**PITTSBURG UNIFIED SCHOOL DISTRICT
HIGHLANDS ELEMENTARY SCHOOL
PORTABLES REPLACEMENT PROJECT**

**BID ADDENDUM NO. 3
May 5, 2026**

PROJECT: Highlands Elementary School – Portables Replacement
4141 Harbor St, Pittsburg, CA 94565

E0.02

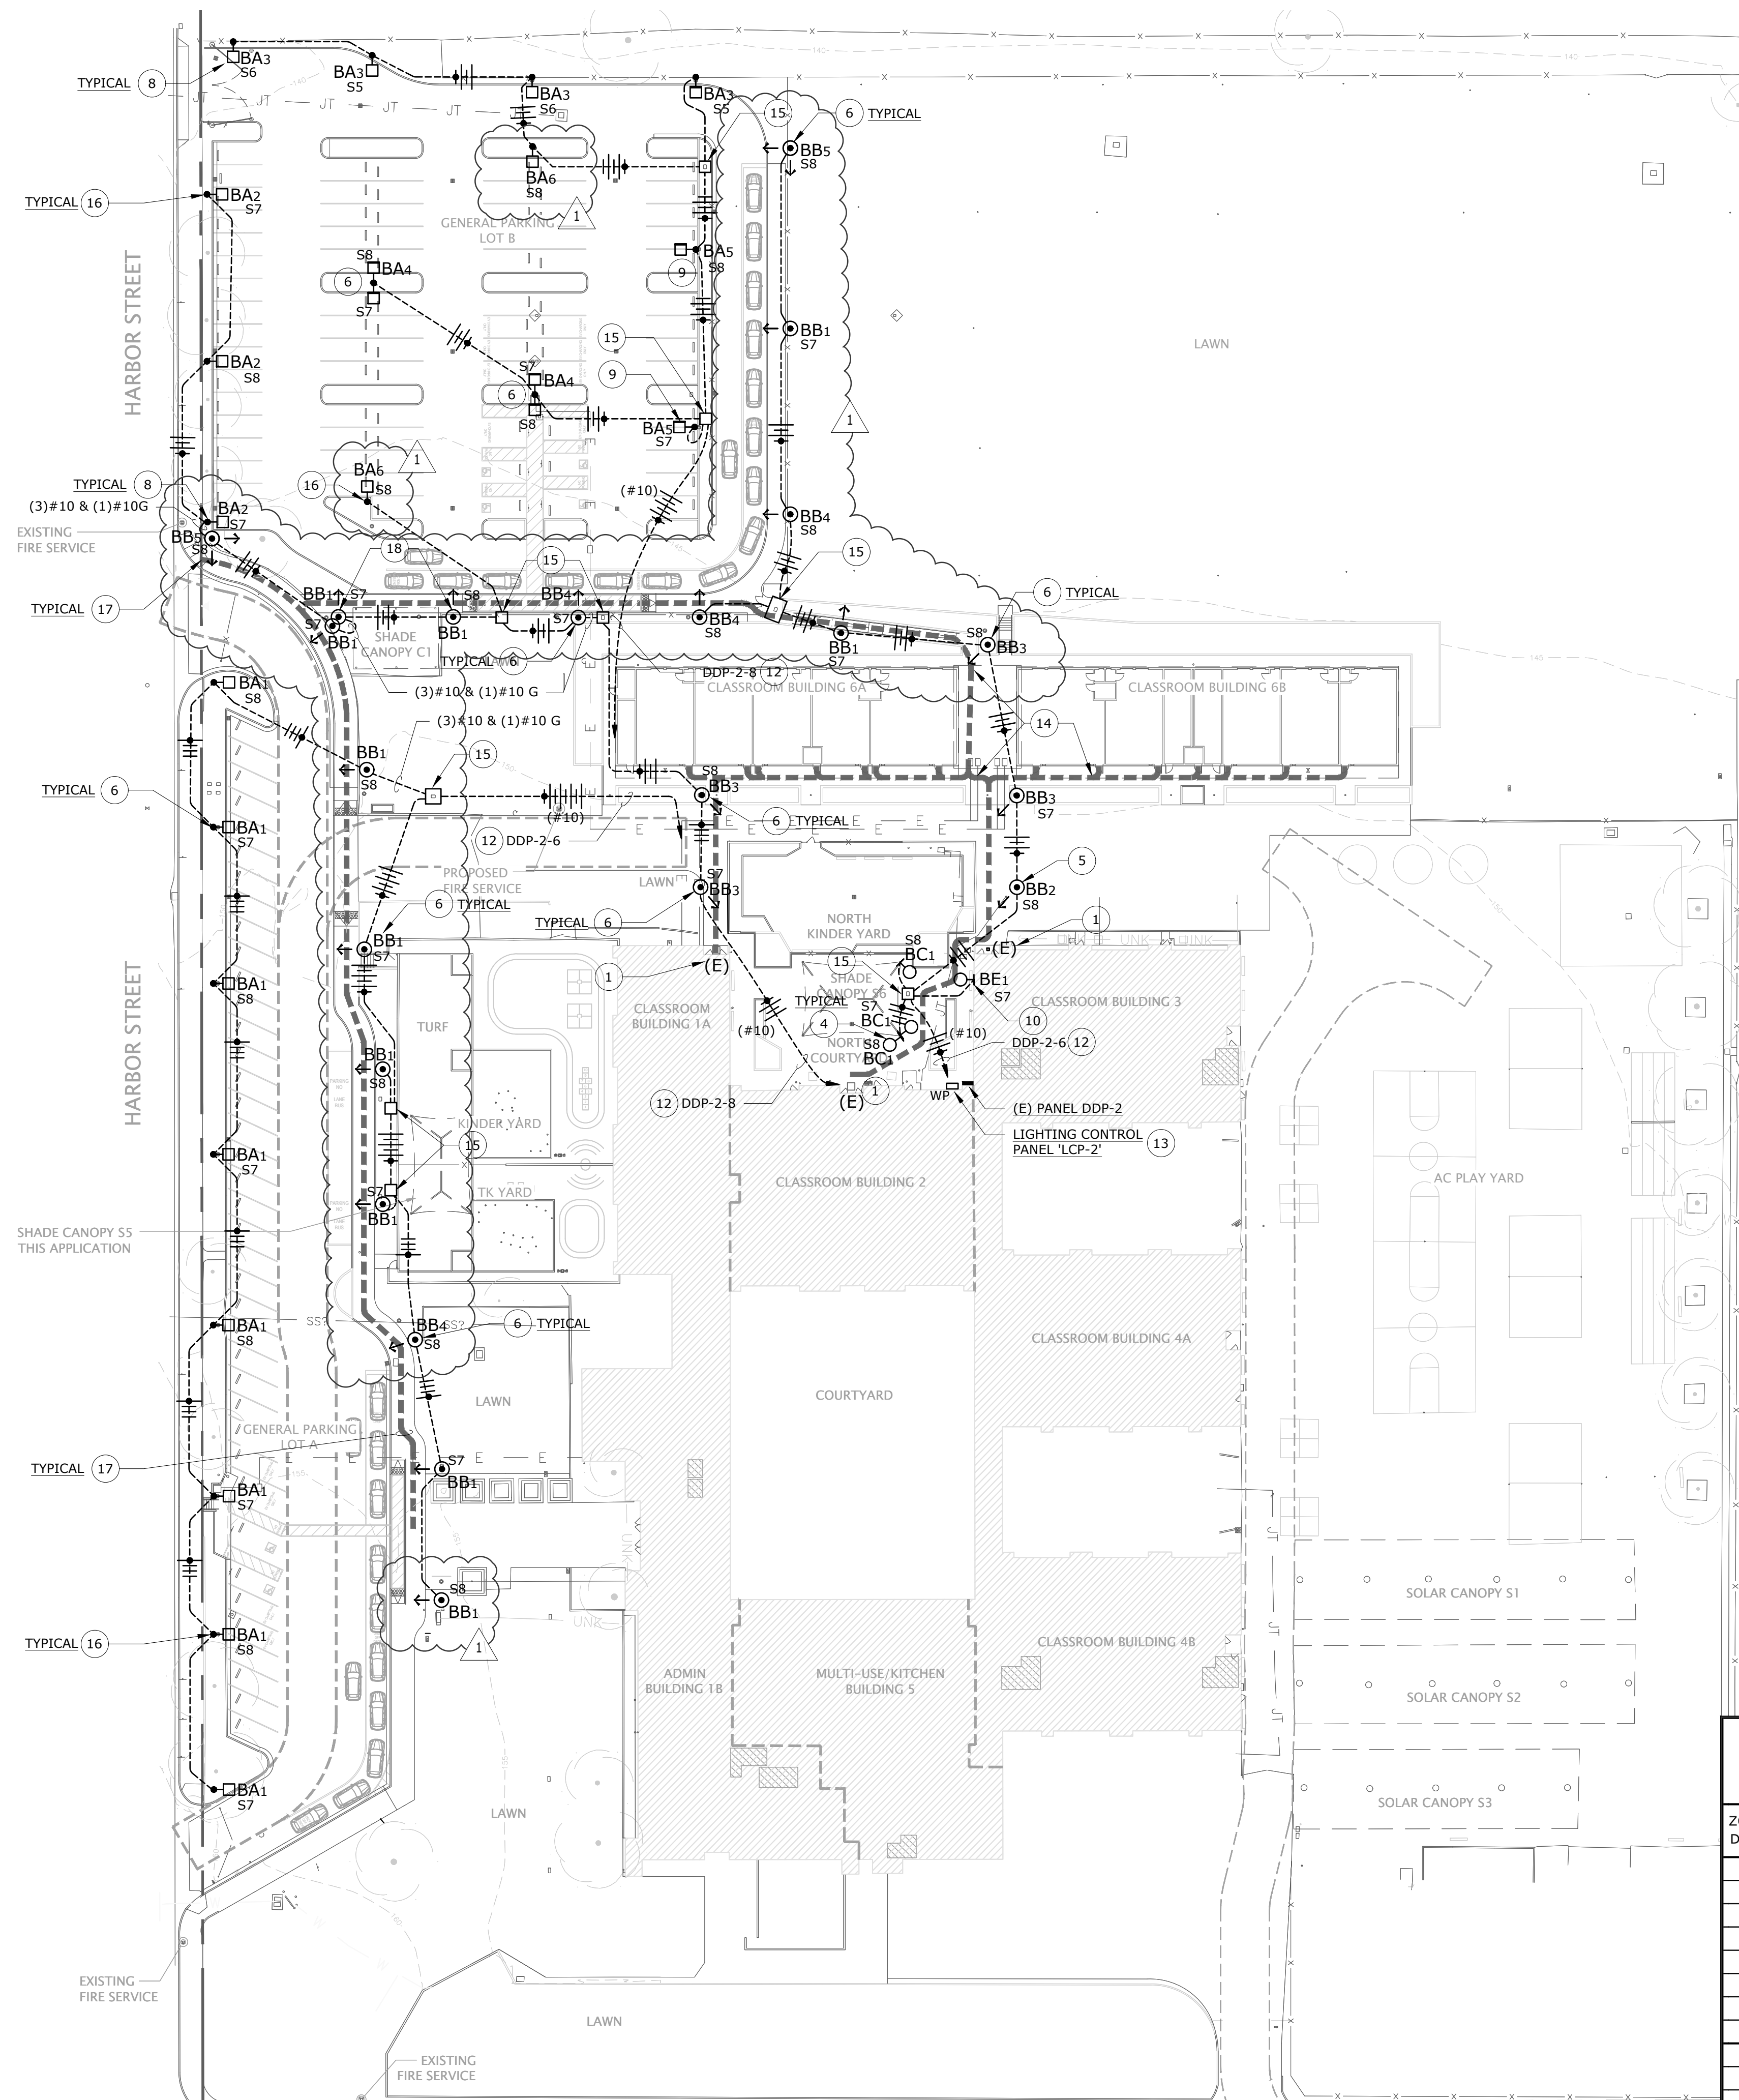
Reference: E0.02 – LUMINAIRE SCHEDULE
Attachment: E0.02 – LUMINAIRE SCHEDULE
Description: 1. Add Fixtures BA6 and BB5 as shown on the attached E0.02.

BA6	POLE MOUNTED IN LANDSCAPE	SIMILAR TO TYPE BA1 EXCEPT TYPE 4 FORWARD THROW OPTICS, PERIMETER FENCE CONTROL TO BE USED WHERE PLACED IN PLAN AND REMAINING SIDE FENCES TO BE STORED AND INSTALLED AS NEEDED IF GLARE BECOMES AN ISSUE IN THE FUTURE . POLE TO BE 16'H MOUNTED IN LANDSCAPE	MCGRW EDISON GALN-SA1A-722-U-T4FT-(FINISH) ACCESSORIES: PFS PERIMETER FENCE STYLE SHIELD. (REFER TO PLANS REGARDING WHERE EXTERIOR OPTICS ARE PLACED) POLE: RSA-4-T-16-A-(FINISH)-(MOUNTING)-1	2200K LED 70 CRI 4600 LM/HEAD	NON- DIM	UNV	33W/HEAD
BB1	POLE IN LANDSCAPE	ROUND AREA LIGHT SIDE ARM MOUNT; CONSTRUCTED OF DIE CAST ALUMINUM ALLOY; NOM. 28" H X 28" D; ANNOZIDIZED ALUMINUM REFLECTOR, SILICONE GASKET AND MECHANICALLY CAPTIVE STAINLESS STEEL FASTENERS. UV STABILIZED ACRYLIC DIFFUSER TYPE 2 OPTICAL DISTRIBUTION. MOUNTED ON 10' POLE IN LANDSCAPE; WET LOCATION IP65 RATED. STANDARD FINISH AS SELECTED BY THE ARCHITECT WEIGHT - 50 LBS	INVUE MSA-SA1A-722-U-T2-(FINISH) POLE: RSA-4-T-10-A-(FINISH)-(MOUNTING)-1	2200K LED; 70+ CRI 4031 LM	NON- DIM	UNV	34W

E1.02

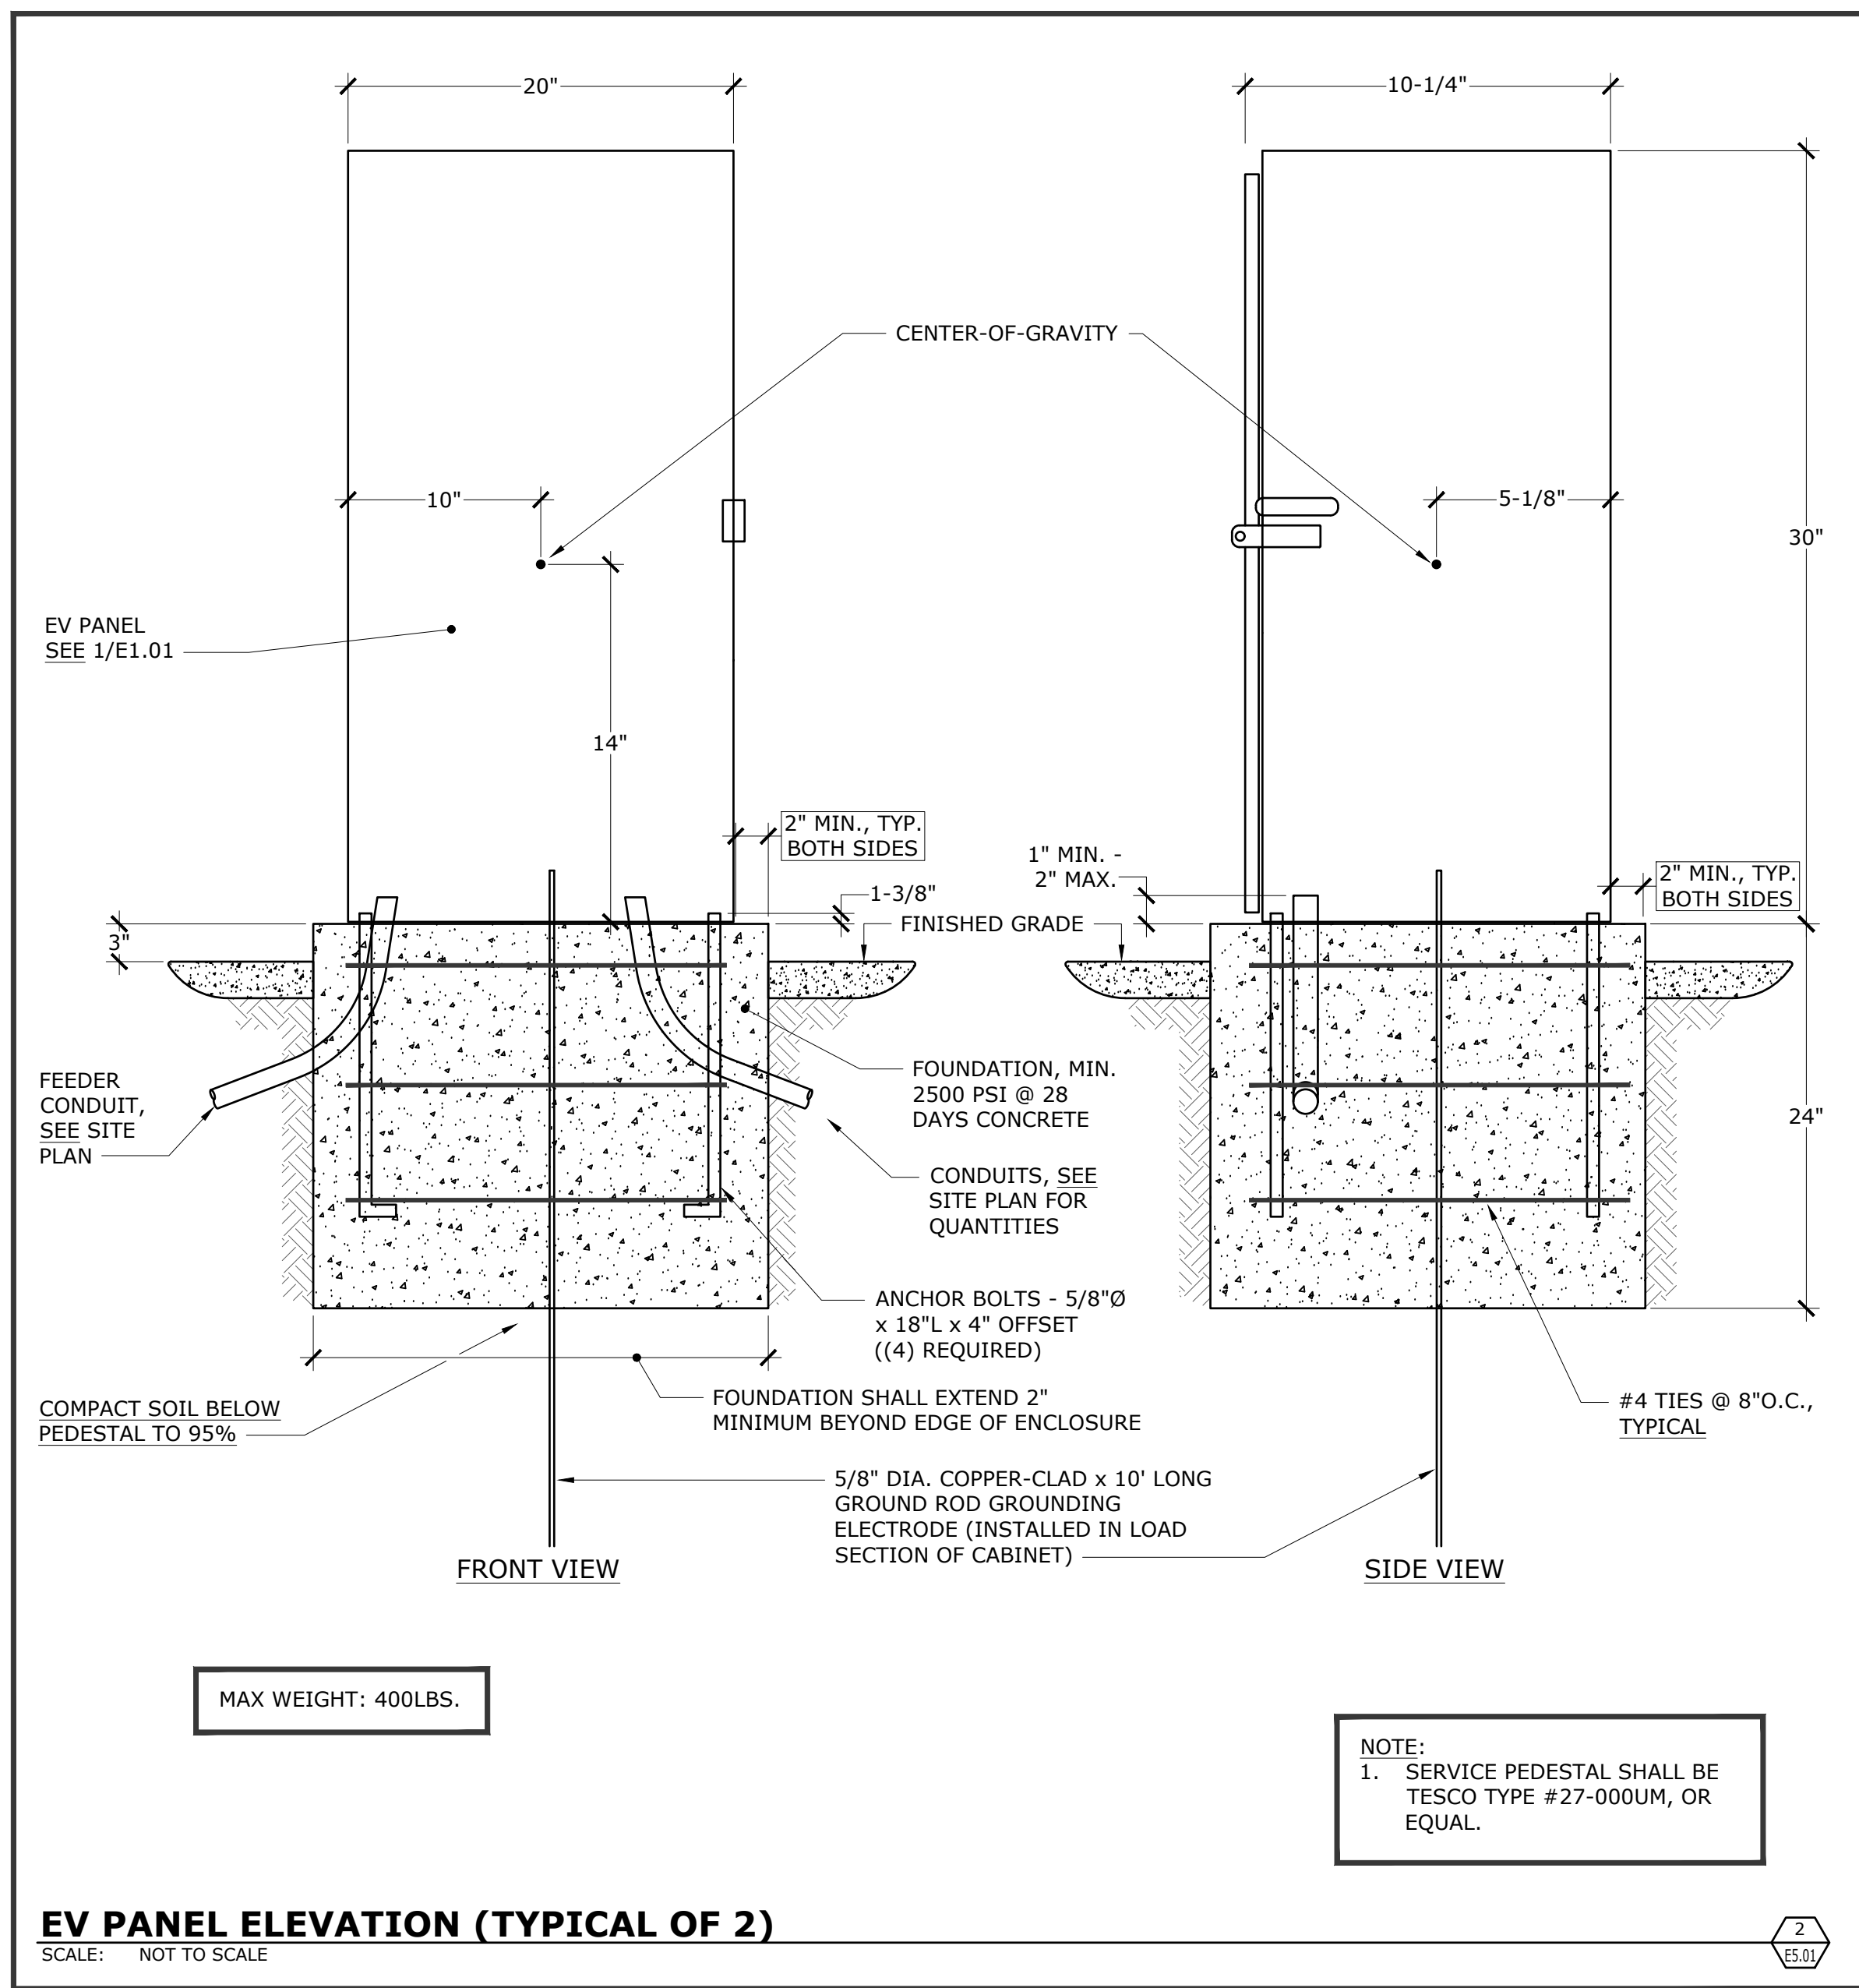
Reference: E1.02 – SITE PLAN - LIGHTING
Attachment: E1.02 – SITE PLAN - LIGHTING
Description: 1. See additional lighting locations.
2. Revise keynotes 3 & 12 and add keynote 18 as shown on the attached E1.02.

- 16 MOUNT CENTER OF POLE AT 3' AWAY FROM ALL CURBS.
 - 17 EXIT DISCHARGE PATH.
 - 18 (2) BB1 POLES TO BE SPACED EQUAL DISTANCE FROM EXISTING SHADE STRUCTURE (+/- 6').

E5.01

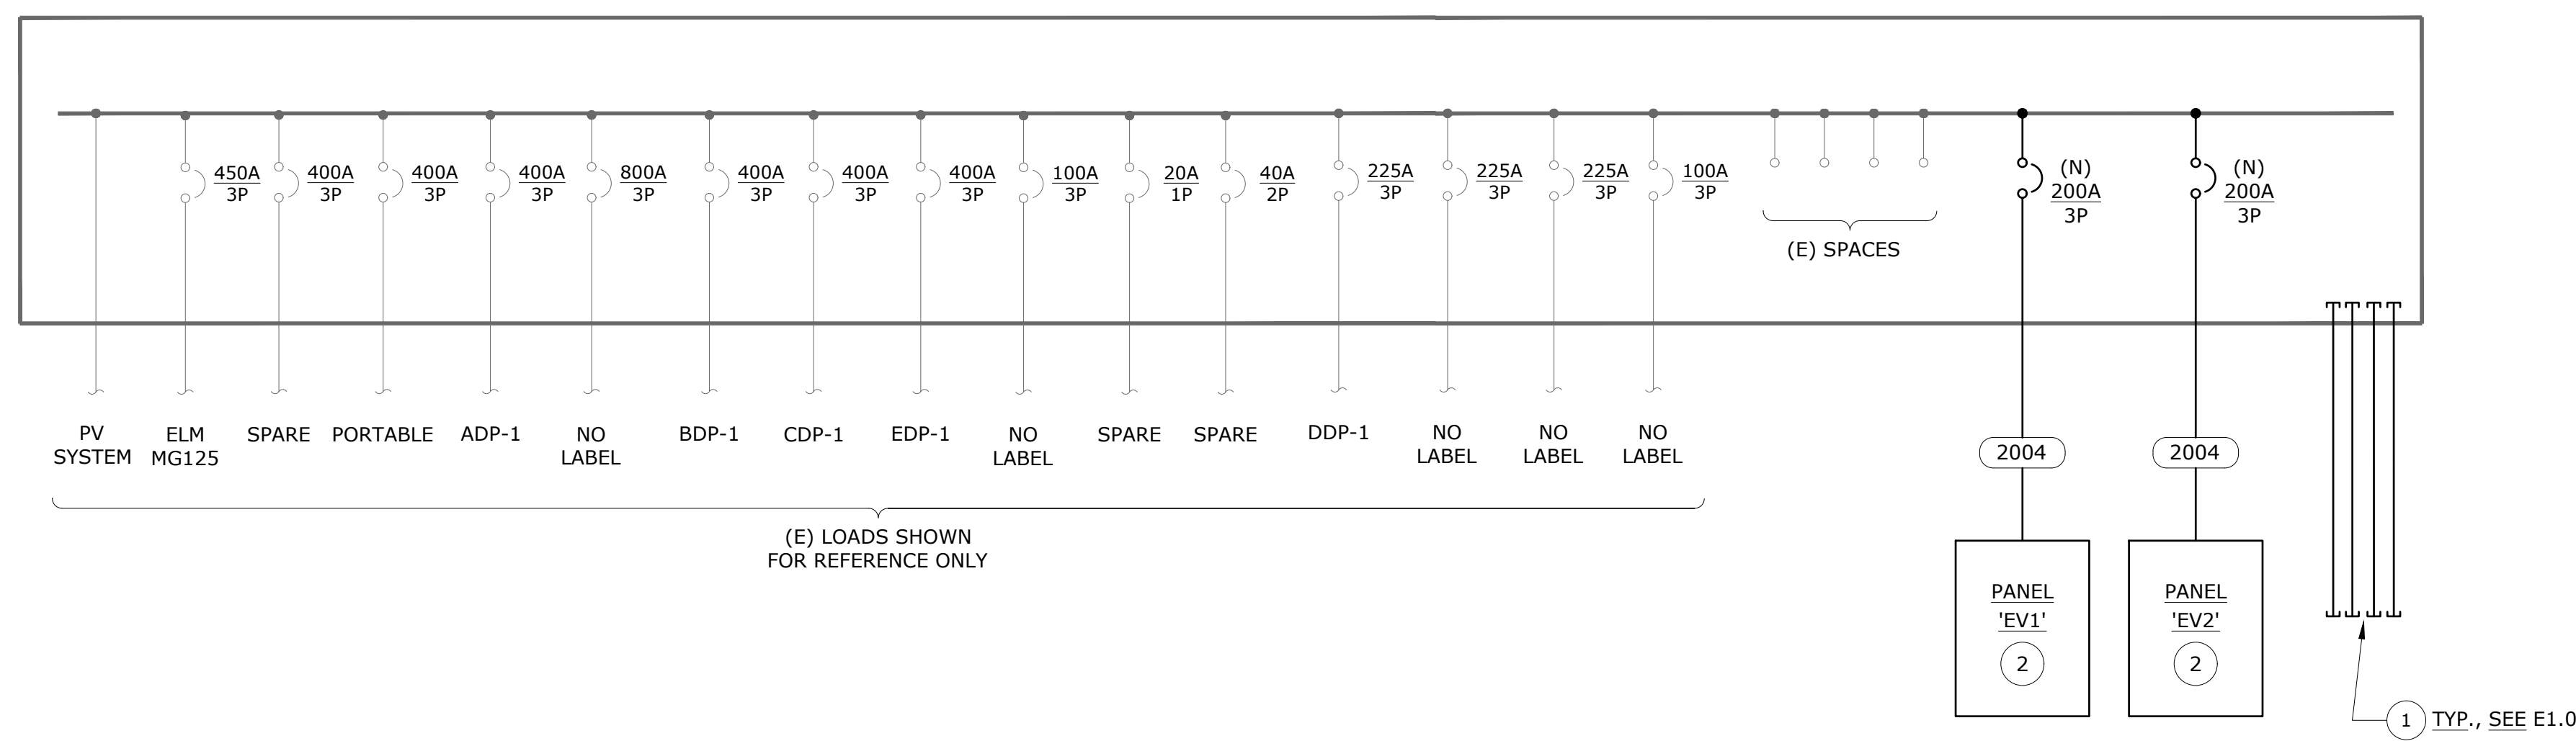
Reference: E5.01 – SINGLE LINE DIAGRAM - ELECTRICAL
Attachment: E5.01 – SINGLE LINE DIAGRAM - ELECTRICAL
Description: 1. Revise Existing Panel DDP-02 as shown on the attached E5.01.
